## Certificate of Appropriateness

1139 E. KNAPP ST. First Ward Triangle HD

PTS ID 114898 COA north and west elevation restoration

3 PHASE 1 - WEST ELEVATION - NEW  
1/4" = 1'-0"

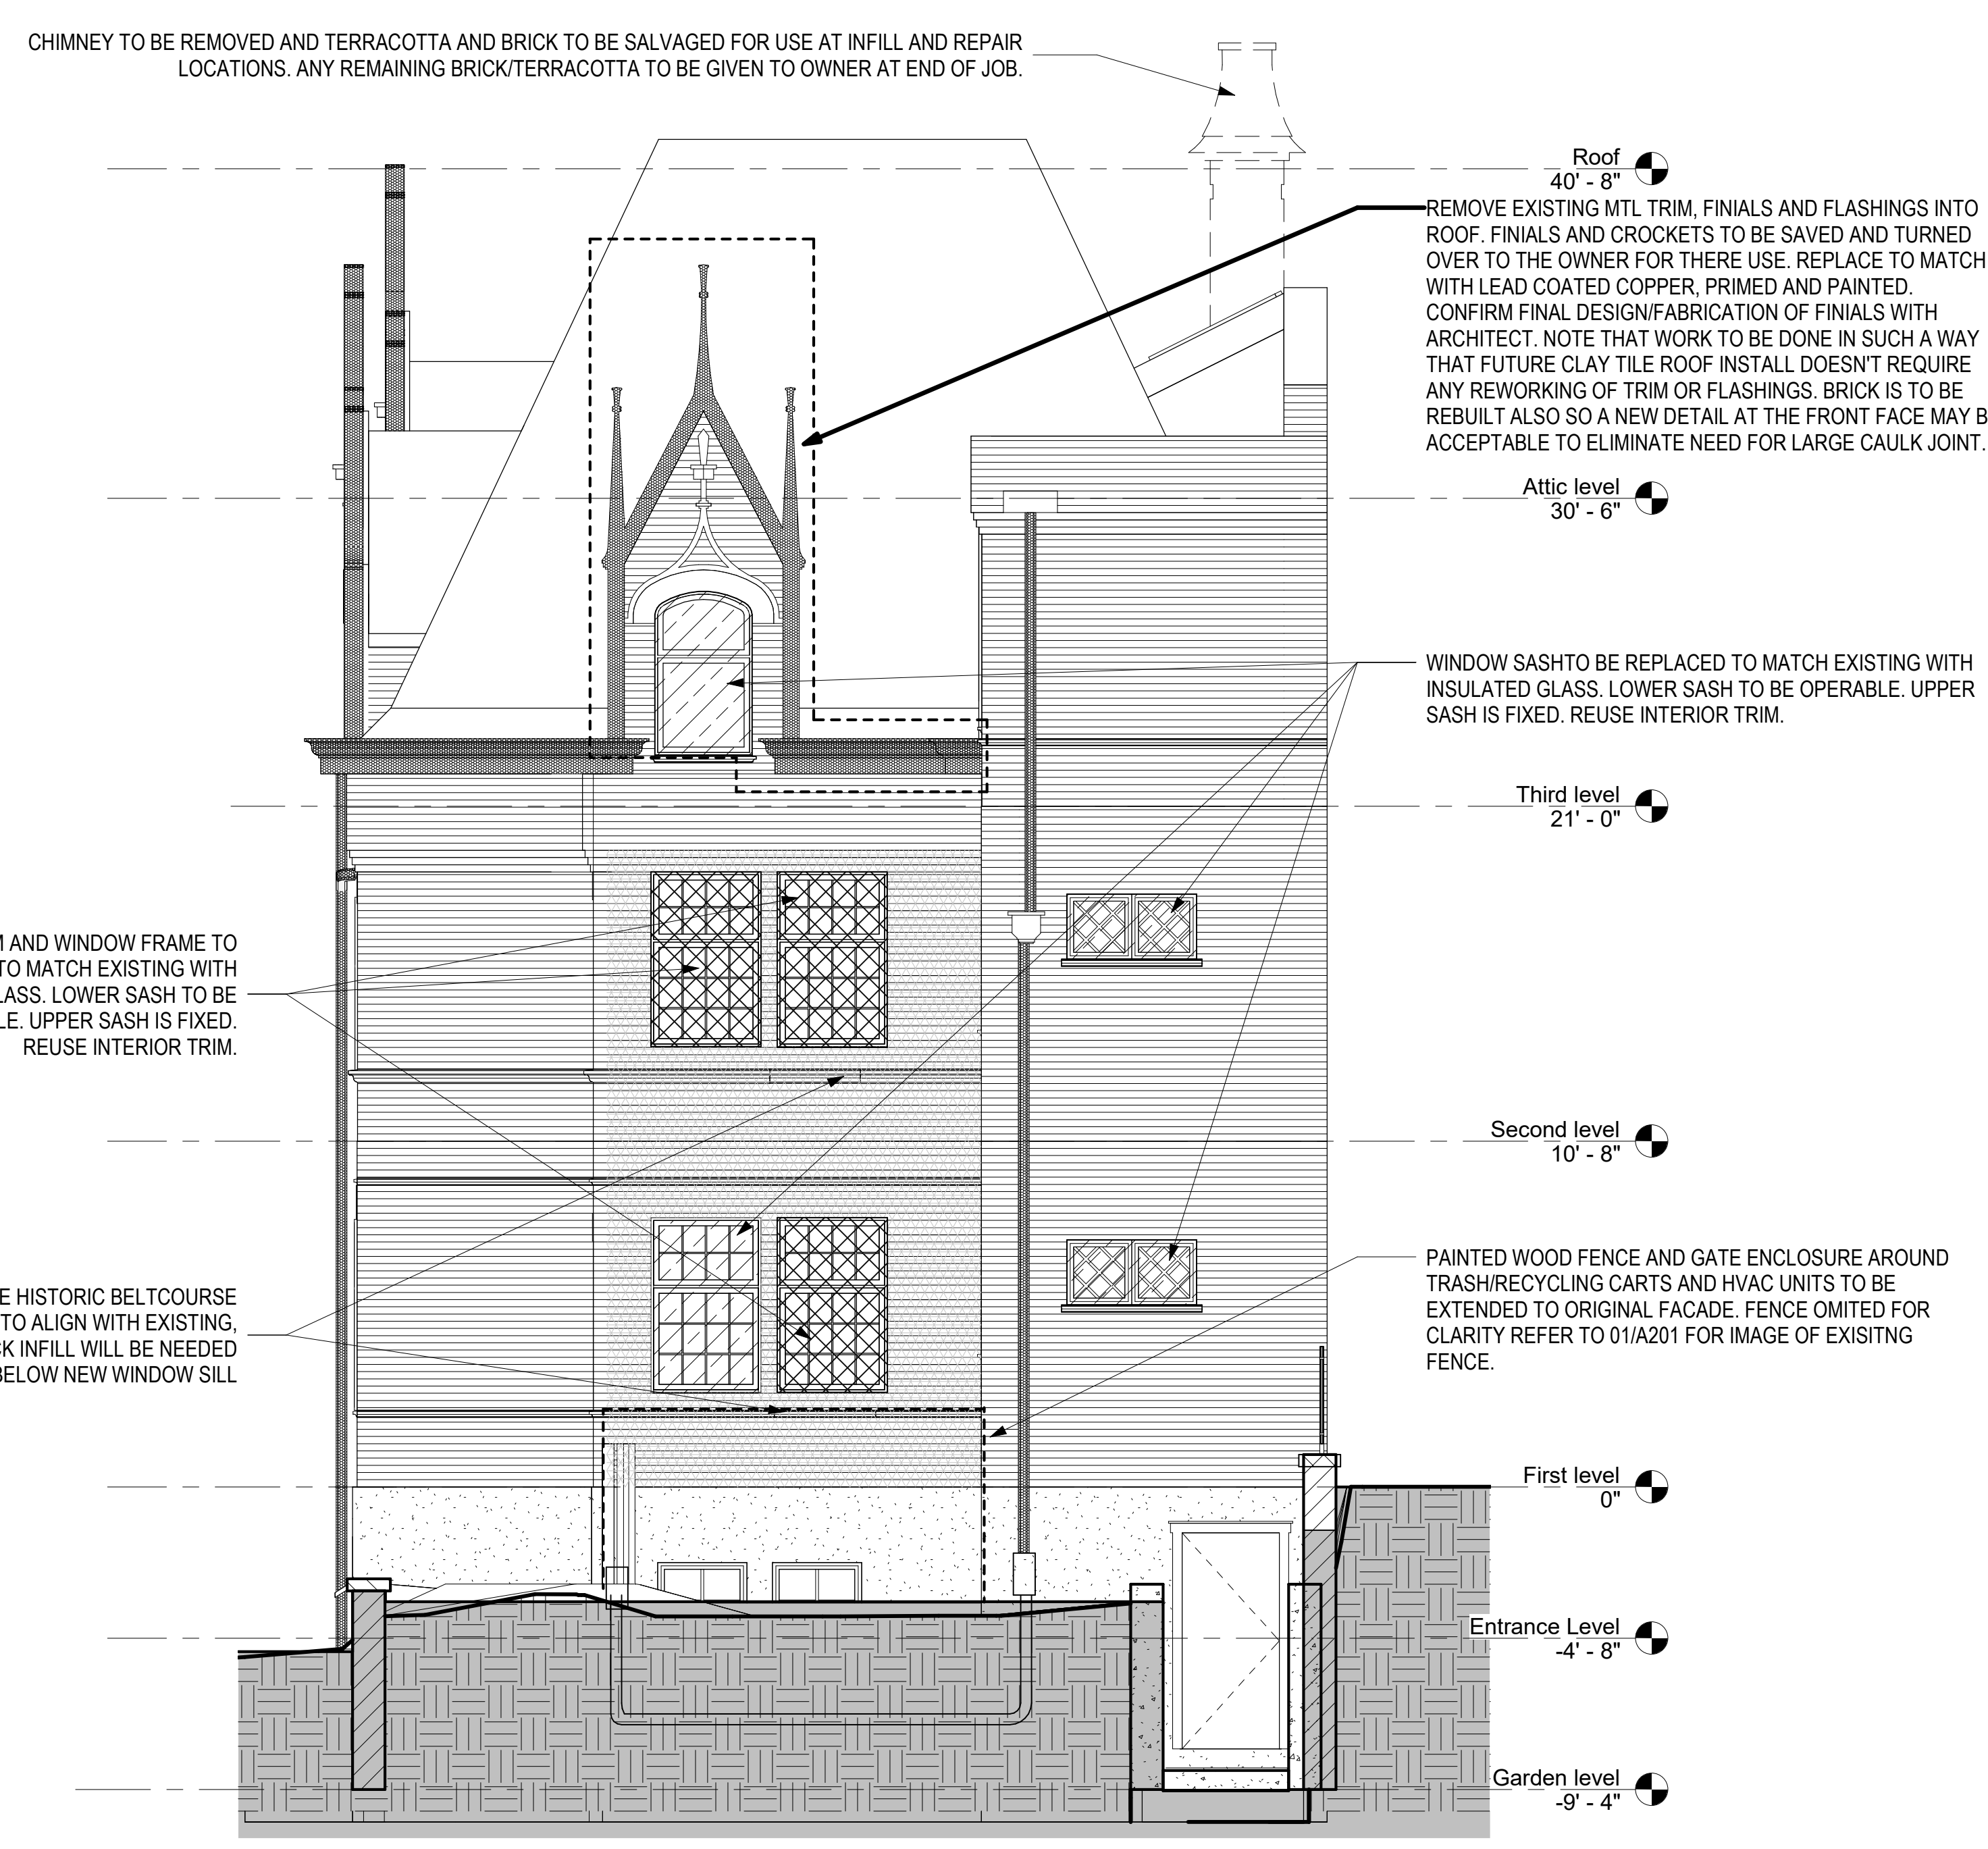
Masonry cleaning must be approved separately because of environmental permitting process. Only hand scraping is permitted under this approval.
